DEVELOPMENT APPLICATION ASSESSMENT REPORT

Application Number:	DA2021/1448
----------------------------	-------------

Responsible Officer:	Thomas Burns
Land to be developed (Address):	Lot 25 DP 13457, 106 Prince Alfred Parade NEWPORT NSW 2106 Lot PO 5606, 106 Prince Alfred Parade NEWPORT NSW 2106
Proposed Development:	Alterations and additions to a dwelling house, including a detached double carport and swimming pool
Zoning:	C4 Environmental Living
Development Permissible:	Yes
Existing Use Rights:	No
Consent Authority:	Northern Beaches Council
Delegation Level:	DDP
Land and Environment Court Action:	No
Owner:	Teresa Aruego Easter
Applicant:	Bruce Stafford & Associates Pty Ltd

This report is submitted to the Northern Beaches Development Determination Panel (DDP) for consideration of Development Application DA2021/1448 for alterations and additions to a dwelling house, including a detached double carport and swimming pool at 106 Prince Alfred Parade, Newport.

Figure 1: section plan highlighting the proposed building height non-compliance

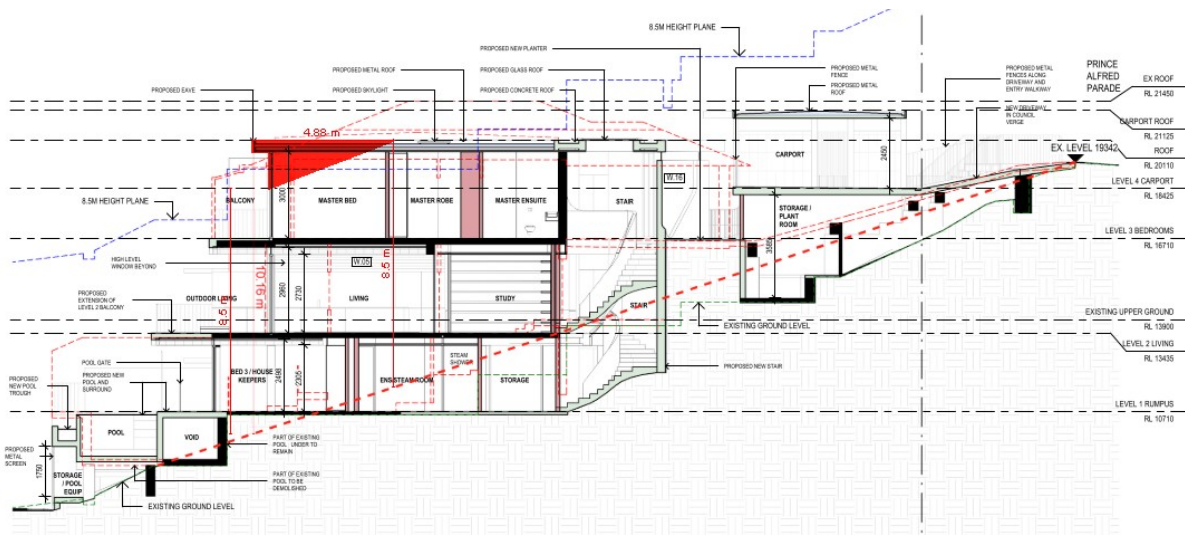
It is important to note that the hipped roofline of the existing dwelling house has a maximum building height of 9.97m and is sited at RL21.45. Whilst the new flat roofline is situated 1.34m below the ridge of the existing roofline, being sited at RL20.11, the maximum building height relative to the existing ground level is increased by 190mm.

Figure 1 below depicts the areas of the proposal that protrude above the 8.5m height plane.

Figure 2: Site plan with FBL

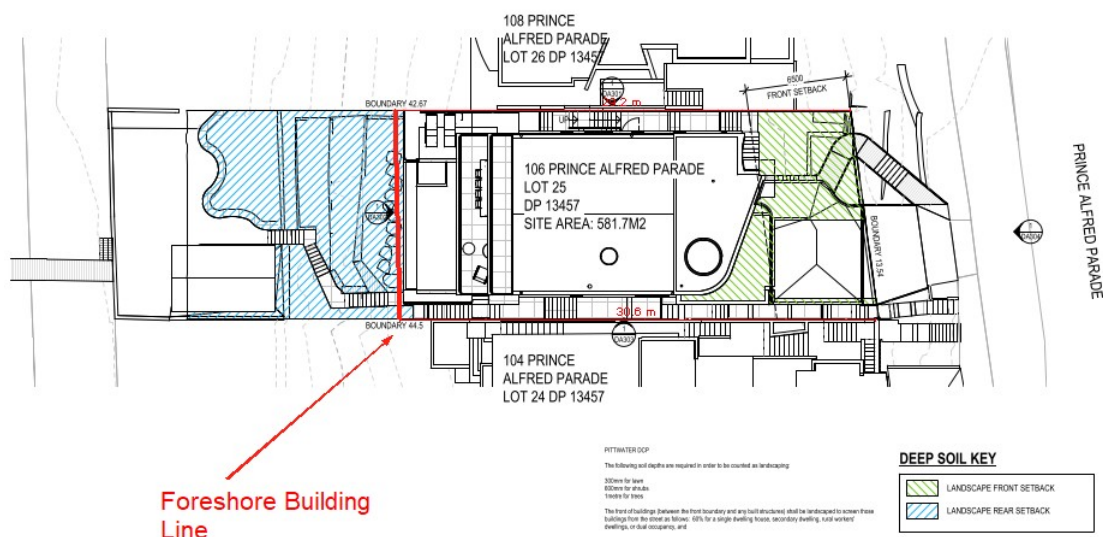
An assessment of the application has confirmed that the proposed works to the dwelling house footprint do not encroach below the FBL. Figure 2 below has extrapolated the FBL on the applicant's site plan, which confirms compliance with this control.

It is noted that the existing access stairs located below the FBL will be retained. Nevertheless, these works are permitted below the FBL as they constitute waterway access stairs.

Figure 4: eastern elevation envelope breach

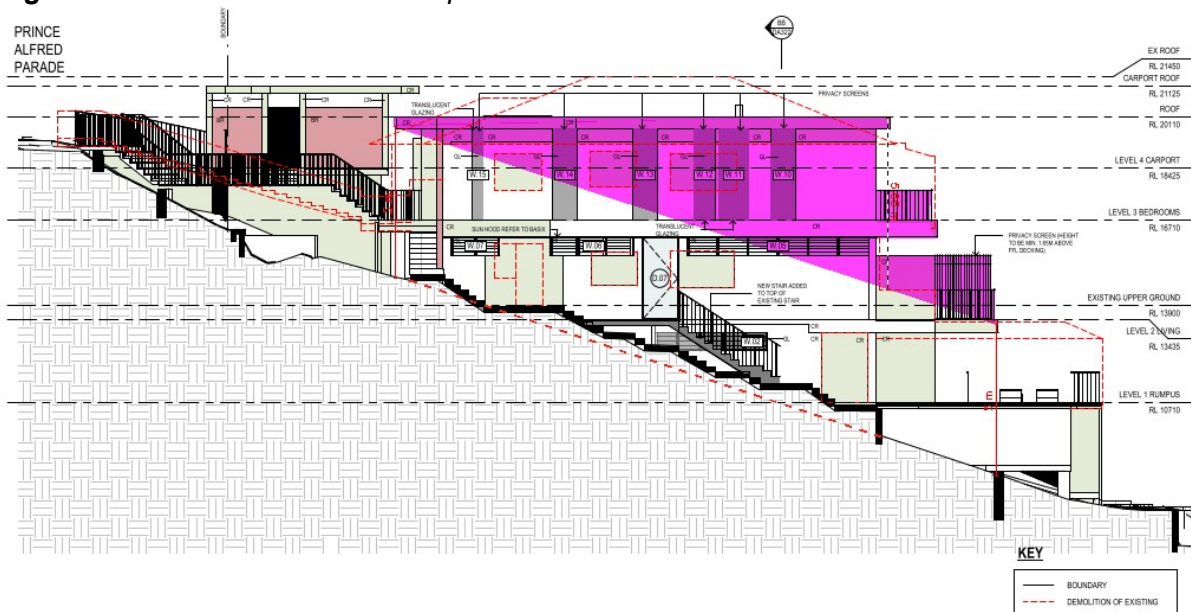
The proposal involves variations to the standard envelope requirement on the eastern and western side elevations. It is noted that the variations to the envelope provision will remain generally consistent to the existing development on the site given the retention of the existing side boundary walls. Figures 4 and 5 depict the extent of the variations.

When considering the development on its merits, it is concluded that the outcomes of the control are achieved. A detailed assessment against the outcomes is provided below as follows:
